MAXWELL PROJECT

SUBMISSIONS REPORT

Figure 1: Location of Receptor 389 and receptors assessed in detail

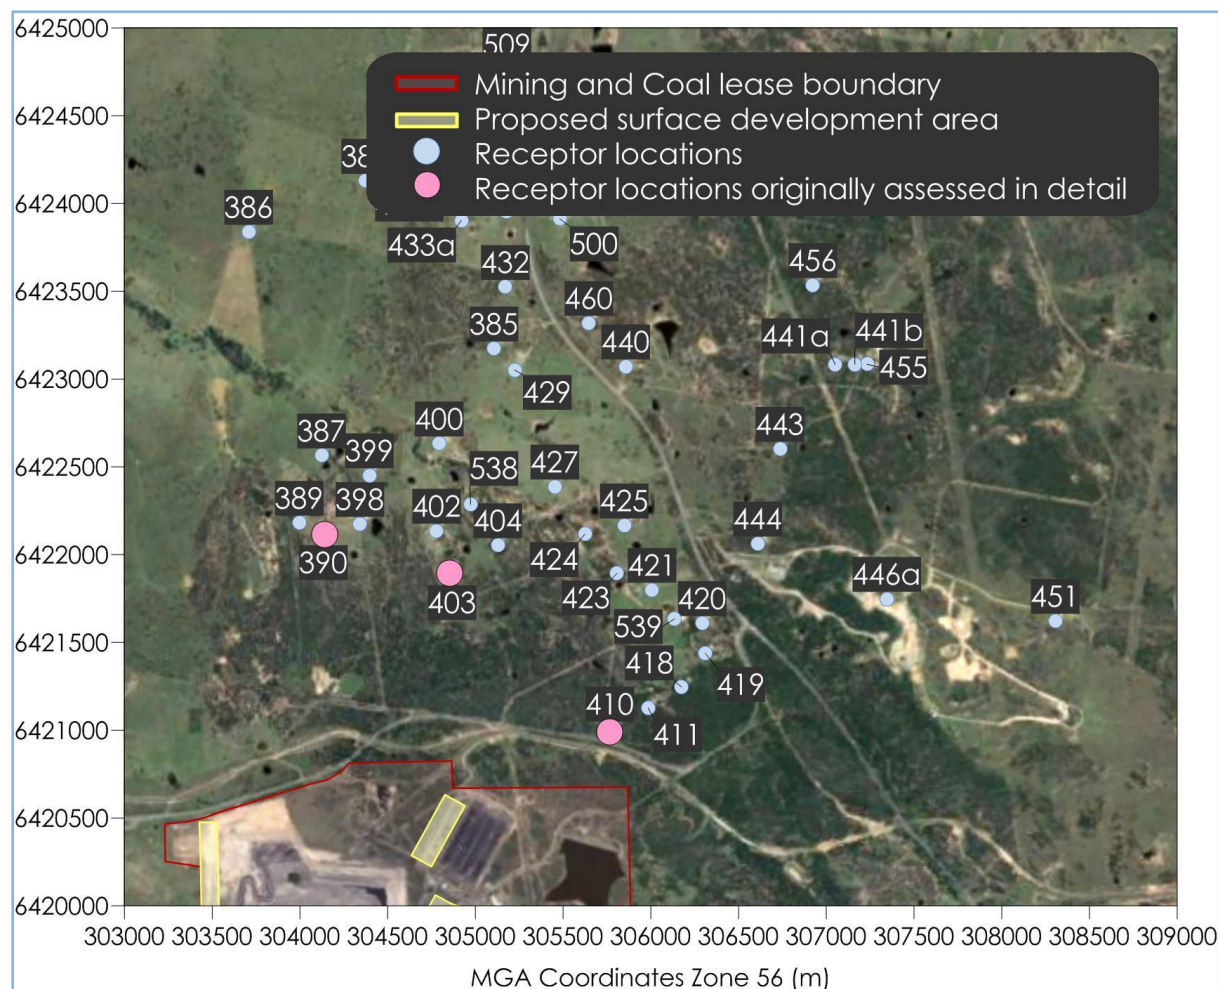
The EPA also requested further detail on the cumulative 24-hour results for Receptor 389 (mine-owned receptor), which was predicted to have the highest Project increments in some cases. The locations of the closest receptors to the Maxwell Infrastructure, which were assessed in detail in the AQIA, are set out in **Figure 1**, along with the location of all other receptors in proximity to the Maxwell Infrastructure, including Receptor 389.

The EPA is correct that Receptor 389 has higher dust levels predicted in some cases than one of the receptors assessed in detail - Receptor 390. Privately-owned Receptor 390 is closer to the Maxwell Infrastructure than mine-owned Receptor 389 and was therefore expected to experience greater Project increments (note receivers were selected for the 24-hour average cumulative assessment prior to results of the dispersion modelling being available).

Figure 1 Low-Frequency Spectra at Representative Receivers - Year 1

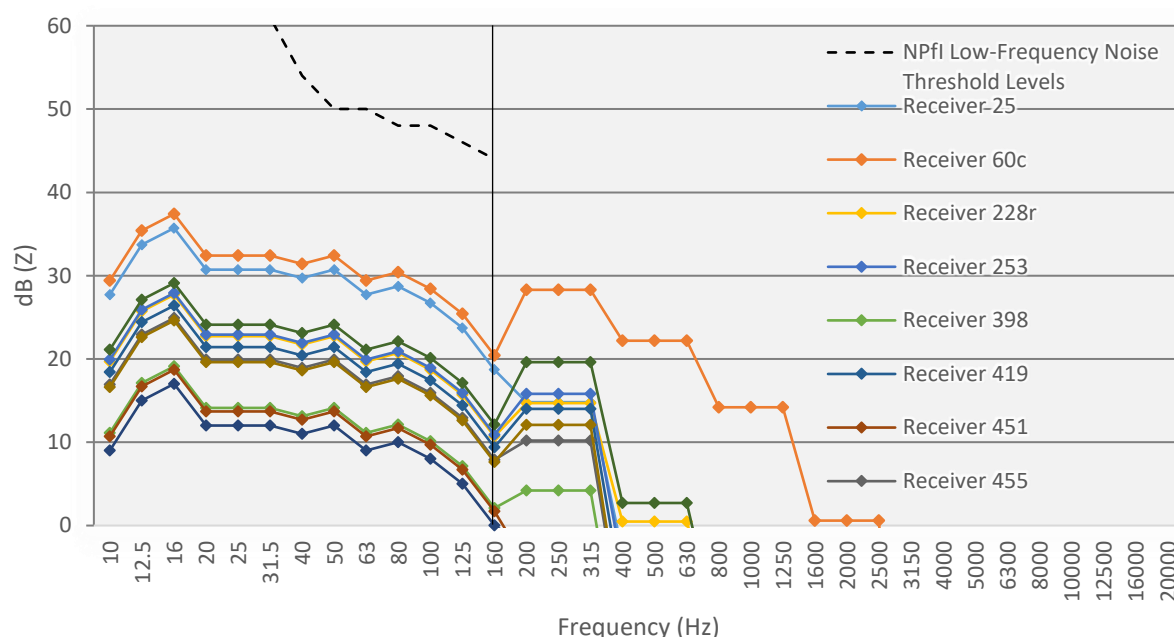
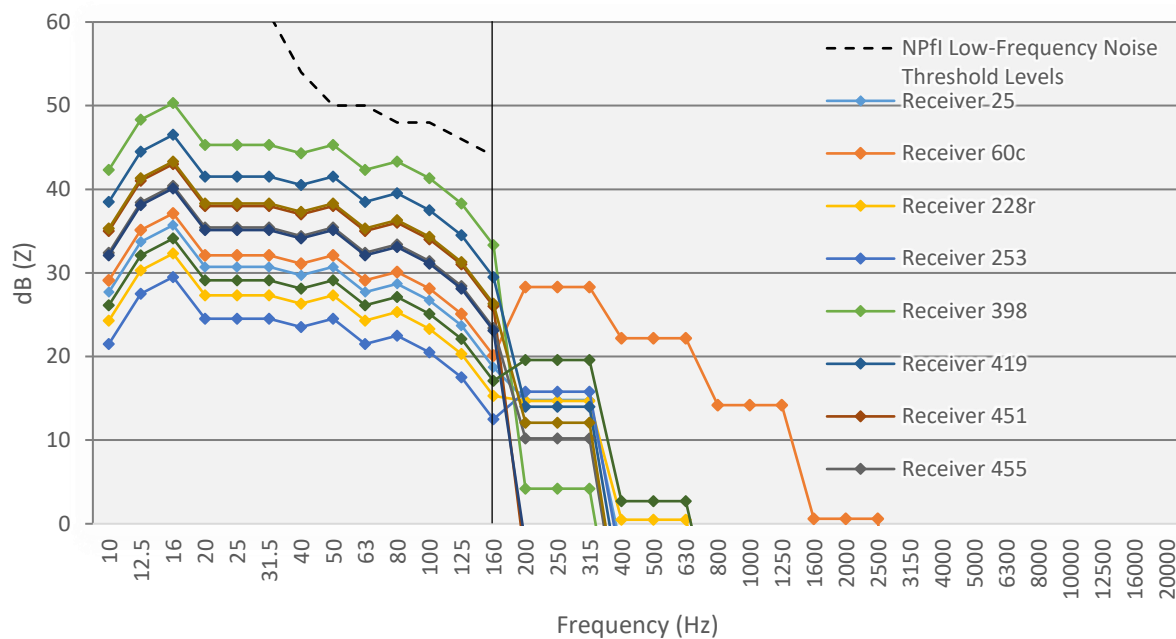
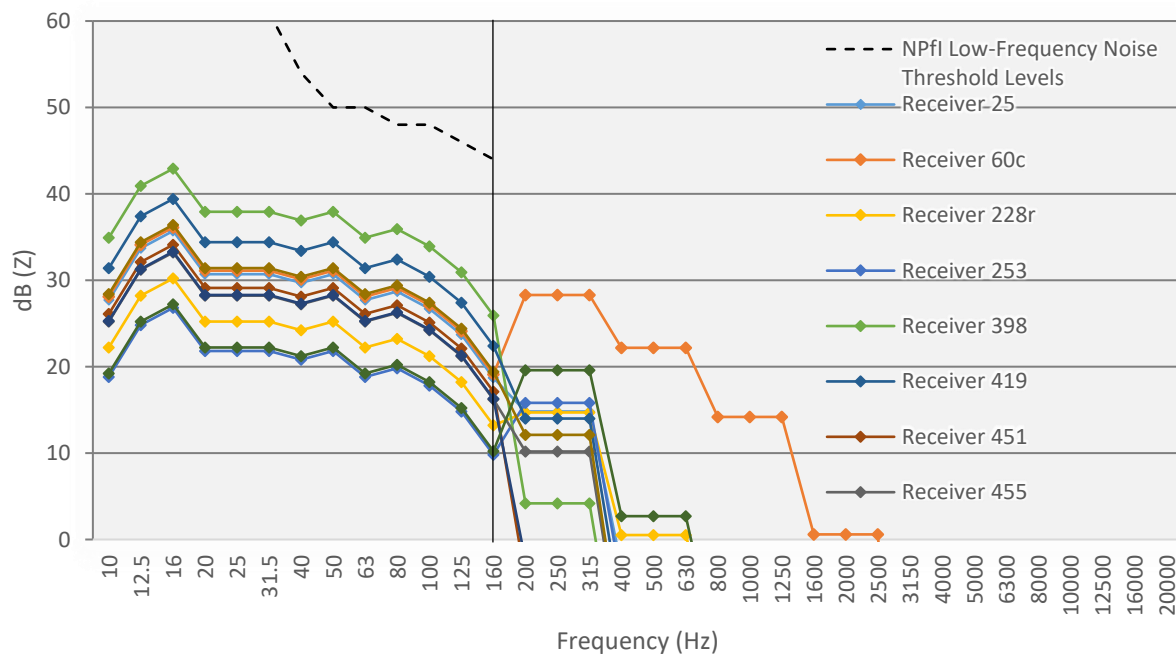
The EPA requested further information on the low-frequency noise assessment and a detailed explanation on the normalising process in relation to low-frequency noise correction undertaken.

In response to the request for quantitative data showing predicted LFN level curves (down to 10 Hz) at all representative receivers and comparison with the *NPfI* low-frequency noise thresholds, WM has prepared the graphs presented in Figures 1 to 3. The graphs show third octave band LFN spectra representative of night time predictions. Note that levels for third octave bands above 160 Hz are based on octave band results and the assumption that the energy in each octave band level is spread out evenly across its three third octave band components.

The low-frequency noise curves, based on data gathered from an audit undertaken for another Hunter Valley mine (Figures 1, 2 and 3 of Attachment 4), show that no privately-owned receiver is expected to experience dominant low-frequency noise.
